APPENDIX A

**Re: Regional and Provincial Comments
Official Plan Amendment, Zoning By-law Amendment, and Site Plan
Town Files: OP-AM-01-22, AM-03-21, SP-06-21
Owner: Avaia Development and Real Estate Ltd.
Agent: Mary Lou Tanner (Niagara Planning Group)
15 Highway 20 East
Town of Pelham**

RE: **Zoning By-Law Amendment and Site Plan Approval
15 Highway 20 East**

Site Servicing Plan

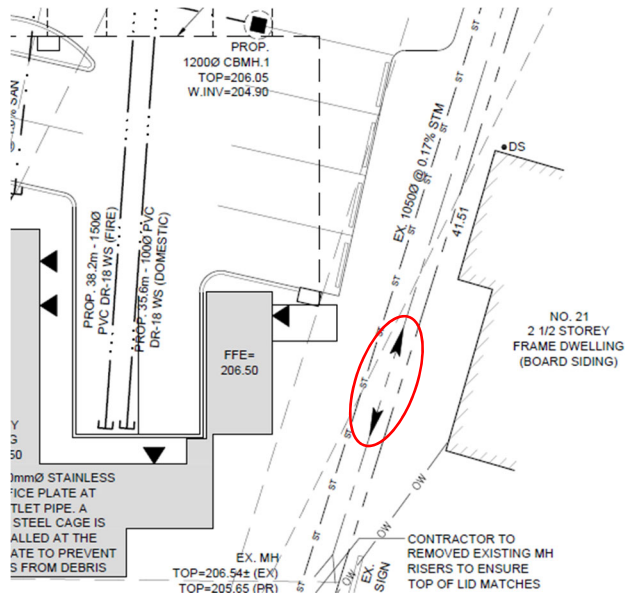
That the developer clarify what the arrows are for. Please see below.

Figure 1: Site Drainage Plan

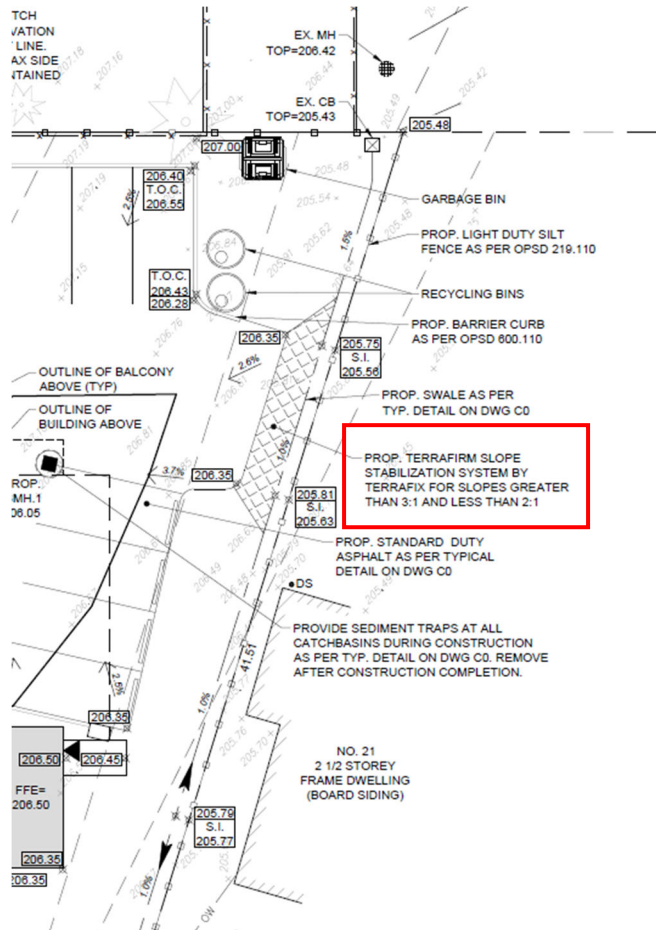
2. Staff request clarification on the use of the “Terrafirm Slope Stabilization System” within the easement.

- Staff have concerns regarding adequate cover for the 1050mm \varnothing storm sewer with the proposed slope along the eastern side of the property. Please ensure that there will be adequate cover as per Ontario Provincial Standards.

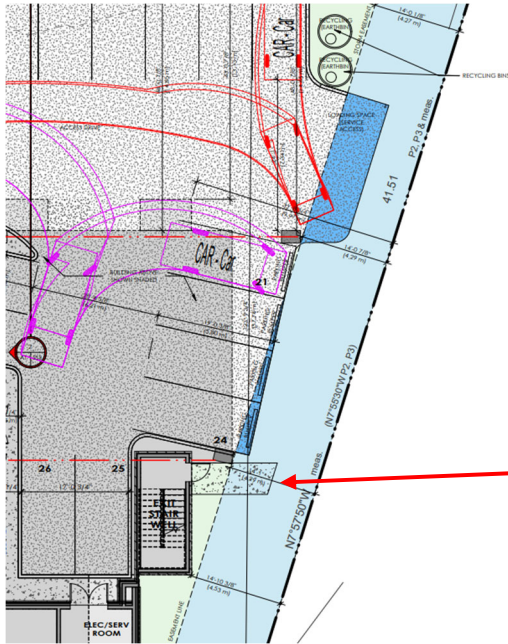
4. That the developer confirm that the area shown below will be a concrete sidewalk?

Will this be a concrete Sidewalk?

Site Drainage Plan (C2)

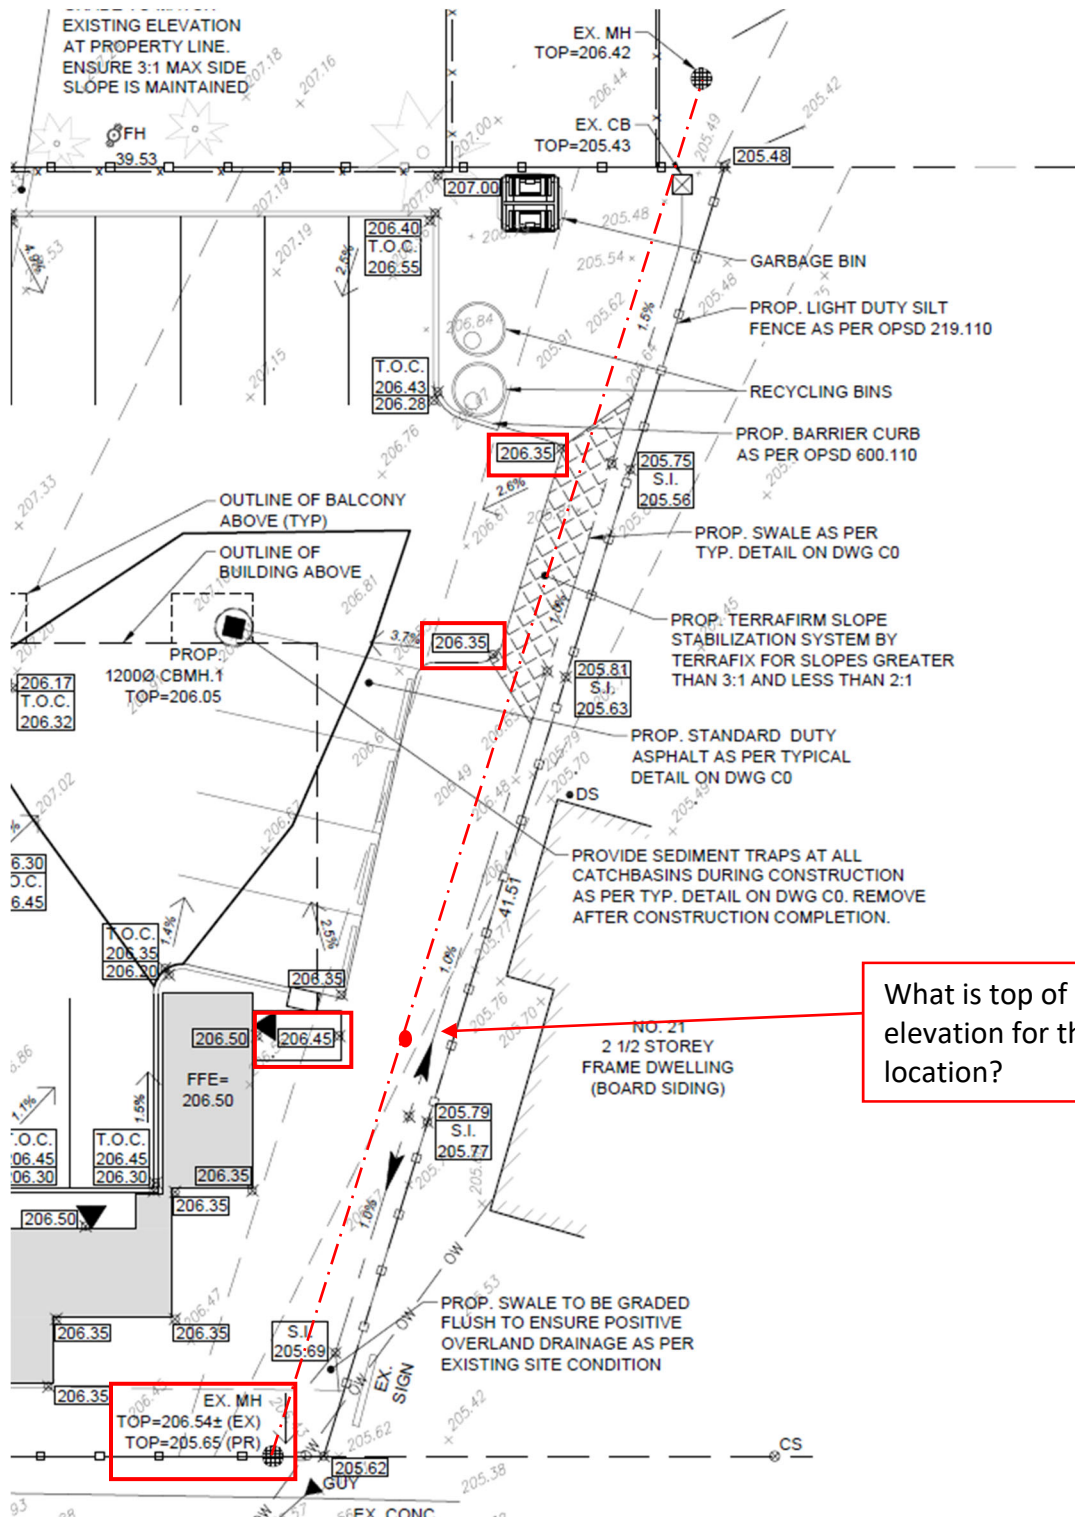
Town Staff request more information regarding the proposed swale.

Staff request confirmation that there will be adequate cover for the existing STM.

What is top of pipe elevation for this location?
